# 91-20-3 CONVERTIBLE WINDOW SCRATCHED - SEAT LATCH PROTECTORS

TECHNICAL SERVICE BULLETIN

Model LINCOLN-MERCURY: 1991 CAPRI  
Group Body  
Bulletin No. 91-20-3  
Date October 2, 1991  
Symptom Scratched Rear Window

Fig. 1: Rear Window Scratches

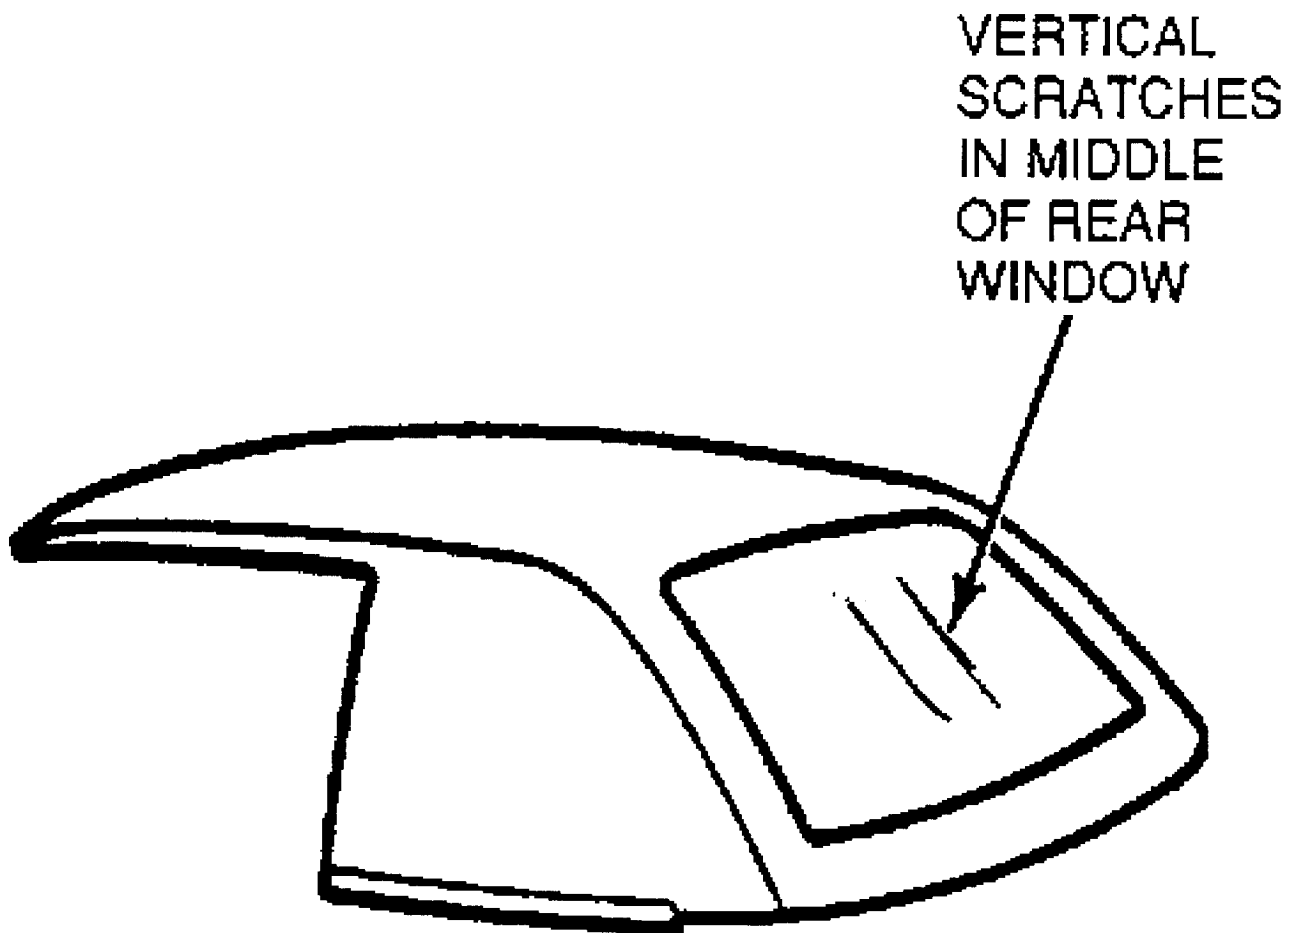
ISSUE: The rear window may be scratched when lowering the convertible top for stowage. This happens when the rear window passes the rear edge of the rear seat back latch.

ACTION: Install three (3) protectors on the rear edge of the latch to prevent window scratches, Figure 1. Refer to the following procedure for service details.

Fig. 2: Installing Protectors

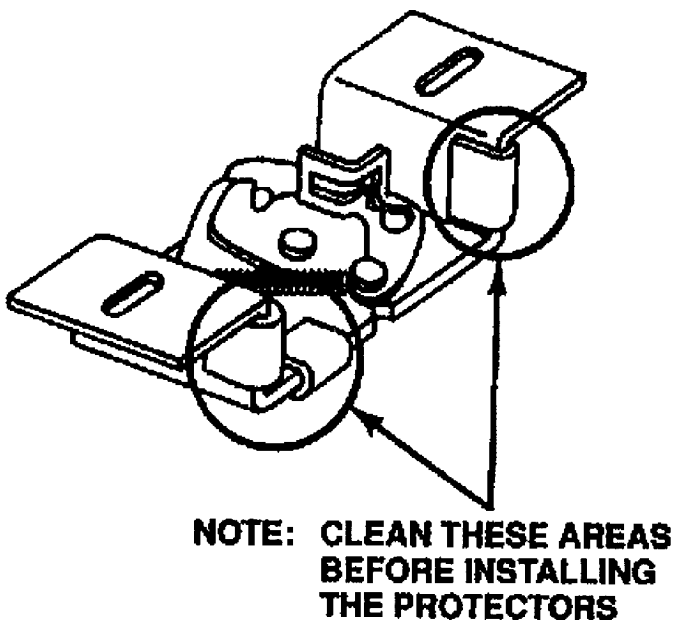
2. Clean the latch with a suitable solvent to remove any grease or foreign material and then dry.
3. Install three (3) protectors, complete with glue on the rear edge of the latch as shown in Fig. 2.

NOTE: STORING THE PROTECTORS IN A WARM AREA WILL AID ADHESION OF THE HOT MELT GLUE.
